Our Ref: 21BRT0549

Your Ref: DEV2022/1310

RE: 15 Nexus Way Southport, Traffic Response to Further Issues

TTM has been engaged to respond to further issues letter for a proposed health care use at the above address. This request from Economic Development Queensland is dated 9 September 2022 and refers to Application Number DEV2022/1310.

Project
GCHKP - RESEARCH
DEVELOPMENT CENTRE
of EXCELLENCE
Drawing
LEVEL B1 GENERAL
ARRANGEMENT PLAN
Scale (A1)
1 : 100
Date Printed
20/09/2022 4:03:00 PM

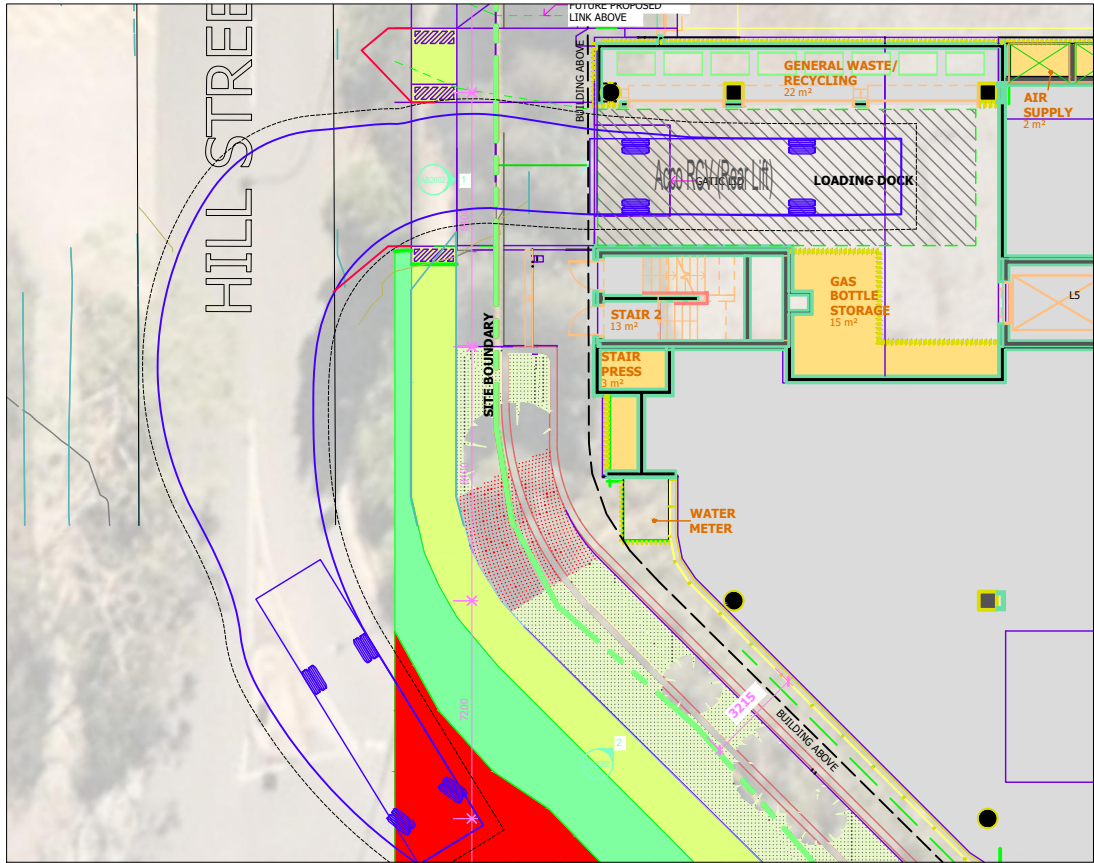
Item 3(a) of the EDQ letter asks to remove parking spaces 34 and 105 to provide pedestrian access to the lifts.

Item 3(q) of the EDQ letter requests confirmation of how cyclists will access the EoT facilities with the ambulance bay an space 14 occupied.

Item 3(s) of the EDQ letter requests further justification for clearance to columns.

Rather than removing these spaces the plan of development has been amended to locate these spaces as close a practical to the wall adjacent to the basement vehicle ramps. The 300mm wall clearance, adjacent to a 2400mm wide parking space, retains approximately 980mm clearance for pedestrians. This is sufficient to provide thoroughfare between the lift lobby and the southern parking aisle.

The updated plans of development shown in **Appendix A** identify a marked 1.3m wide path to provide access for cyclists to access end of trip facilities. Actual clearance is generally expected to be greater to a parked vehicle as cars do not typically park up to the painted line.

The updated plans of development shown in **Appendix A** identify a parking envelopes for critical spaces demonstrating clearance to columns for door opening. Where the majority of spaces are located adjacent to 400mm wide columns, the spaces are separated by 600mm. This provides an extra 100mm clearance for access manoeuvring and door opening, such that the slight intrusion of the column length is mitigated.

PROJECT
HILL STREET, SOUTHPORT
DRAWING TITLE
**VEHICLE ACCESS ARRANGMENTS
RCV SWEEP PATH ANALYSIS**

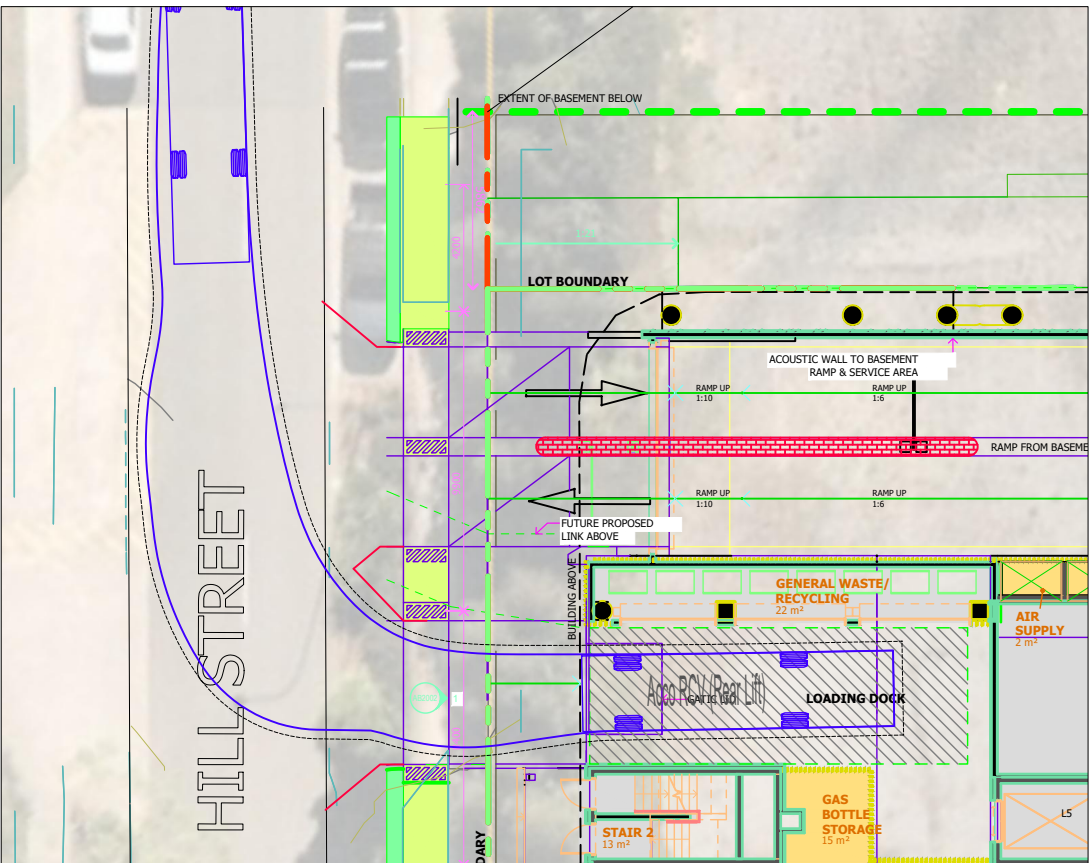
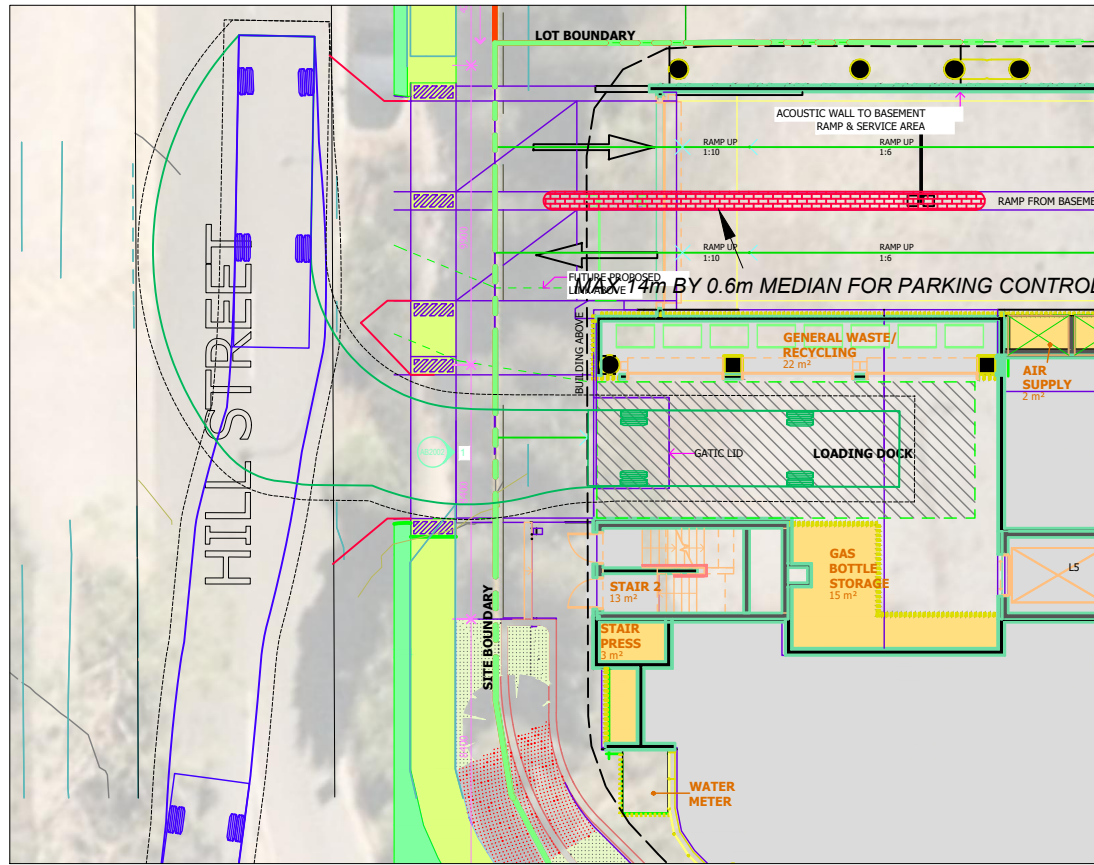
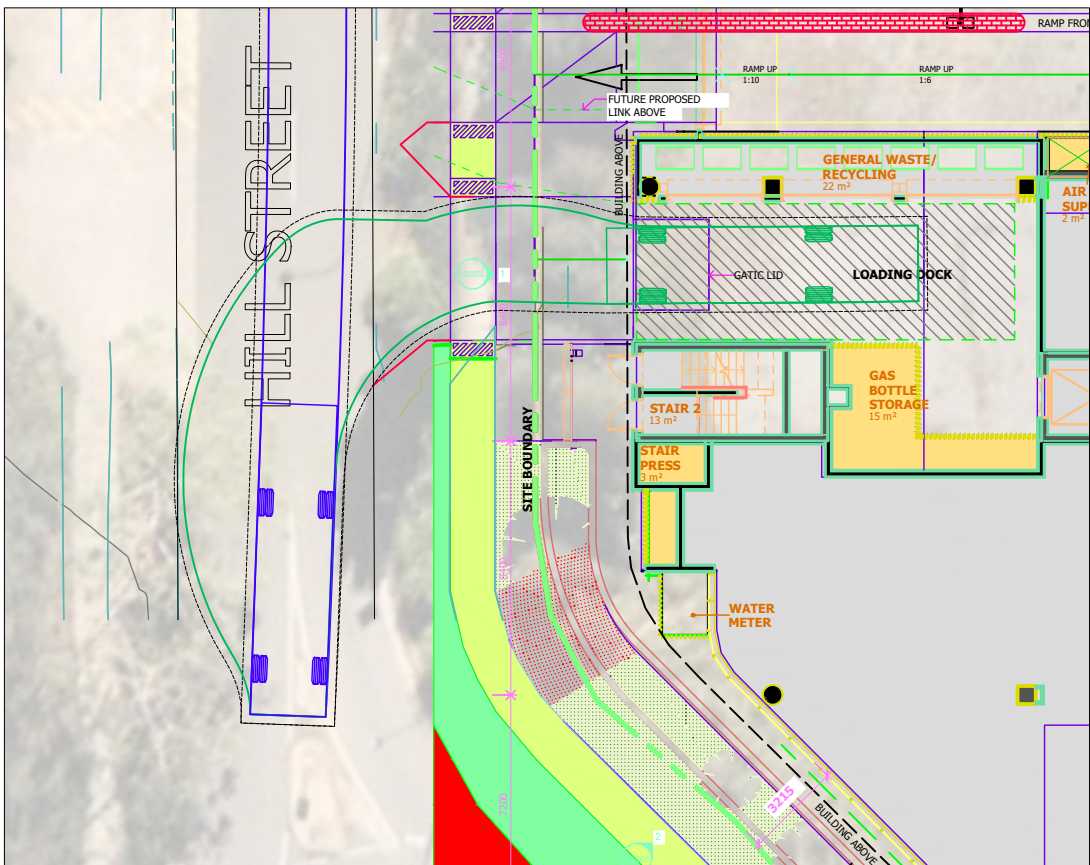
Item 3(j) of the EDQ letter requests swept paths of the RCV and SRV are provided for both directions along Hill Street vehicle accessing this loading bay.

This full set of paths is shown in **Appendix B**.

PROJECT
HILL STREET, SOUTHPORT
DRAWING TITLE
**BASEMENT 1 VEHICLE ACCESS
SWEEP PATH ANALYSIS**

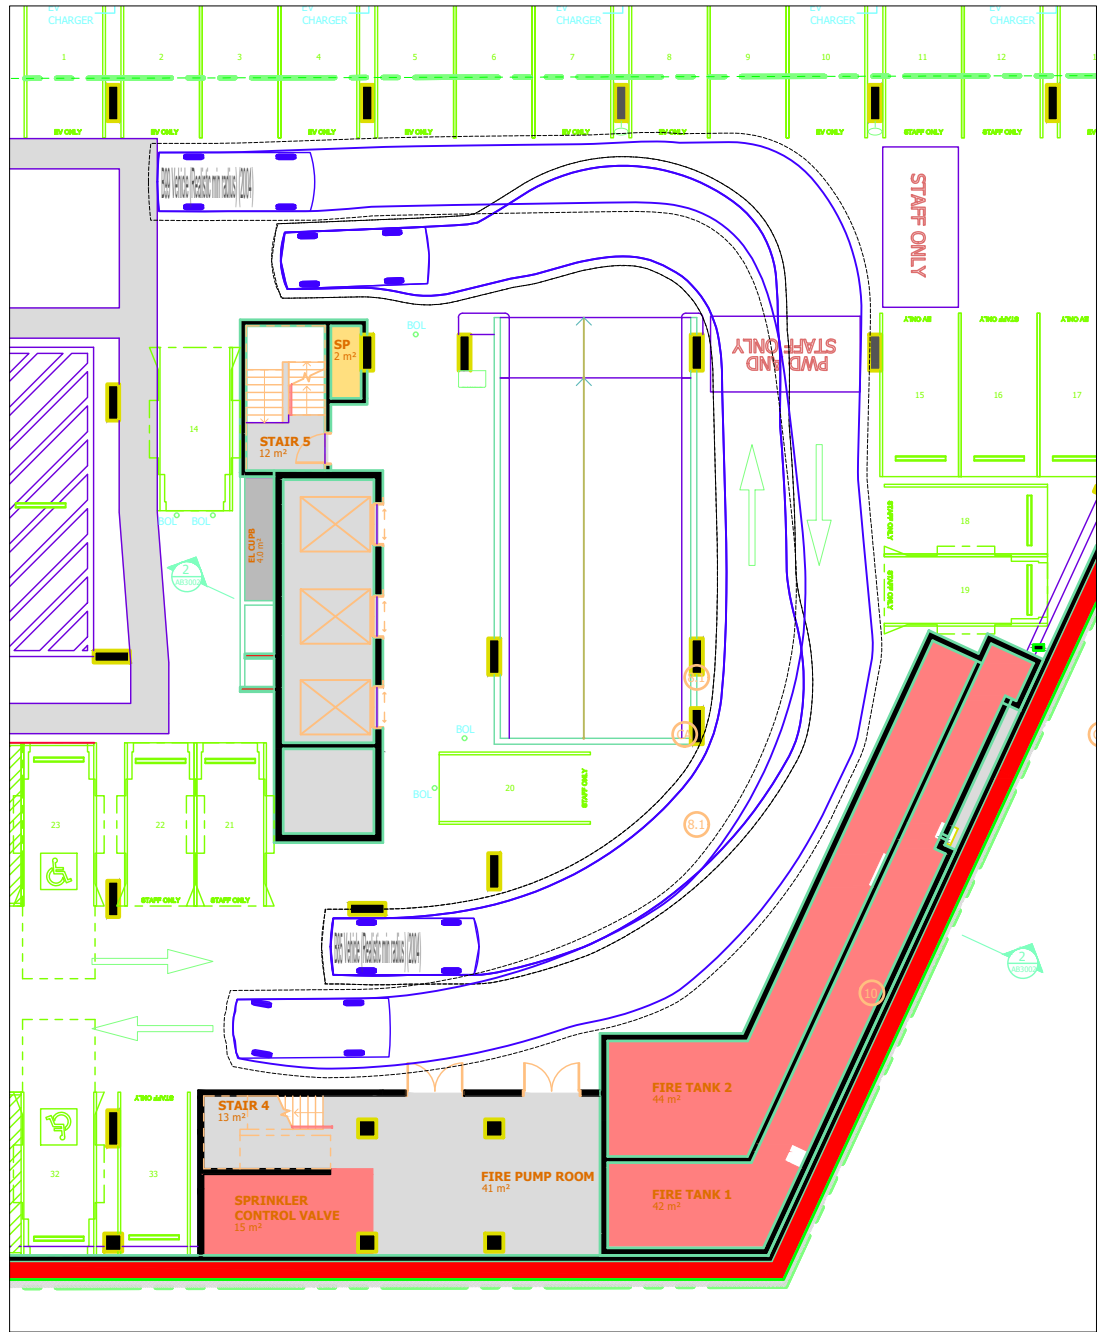
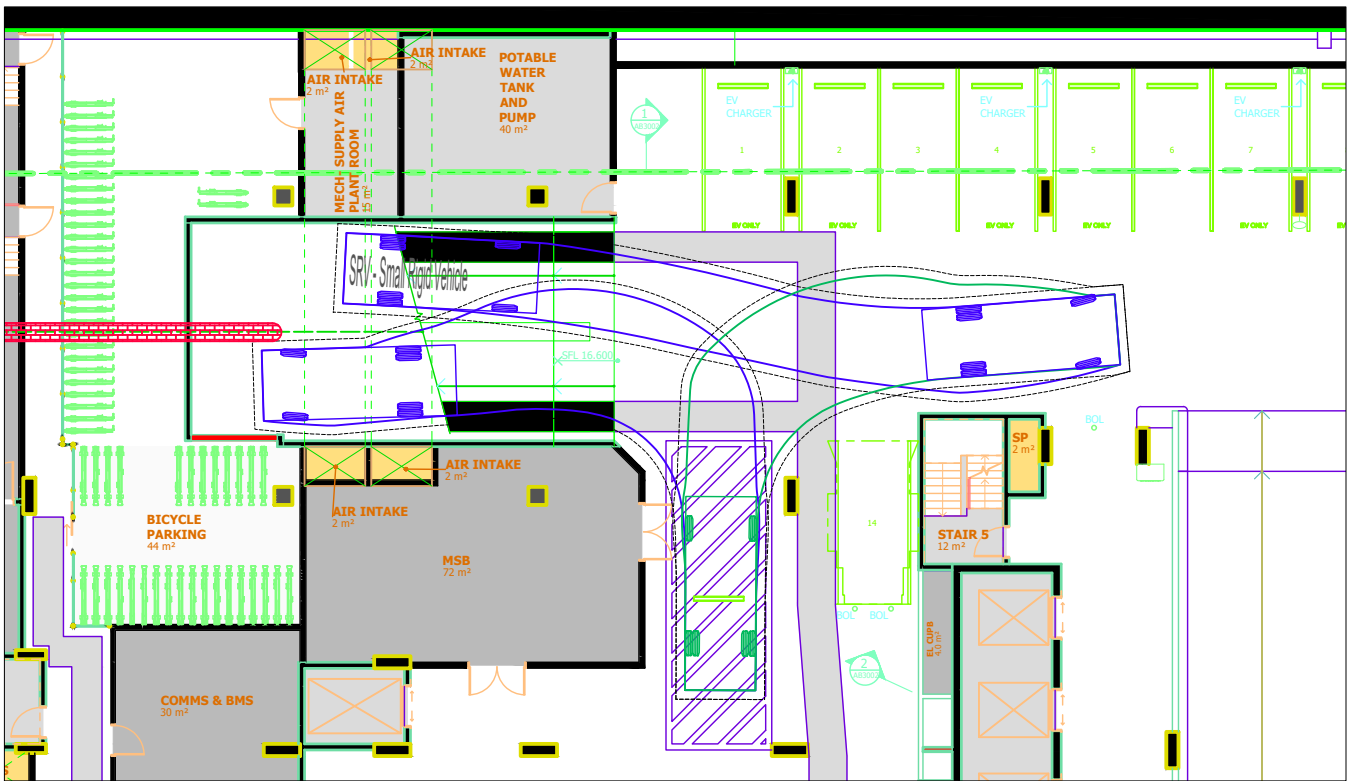
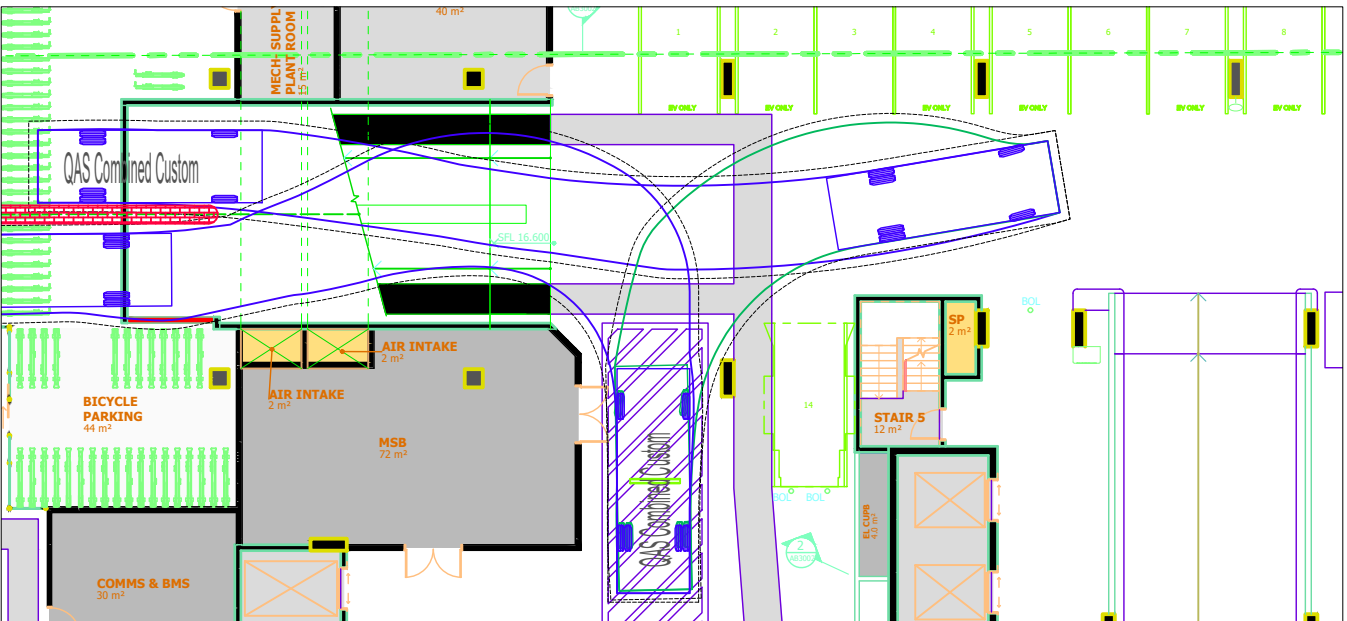
Item 3(l) of the EDQ letter requests swept paths of SRV and ambulance are shown to have clearance to boom gates including 600mm on curved sections.

Item 3(m) of the EDQ letter requests swept paths of the SRV are 300mm clear to parking bay.

This full set of paths is shown in **Appendix B**.

This full set of paths is shown in **Appendix B**.
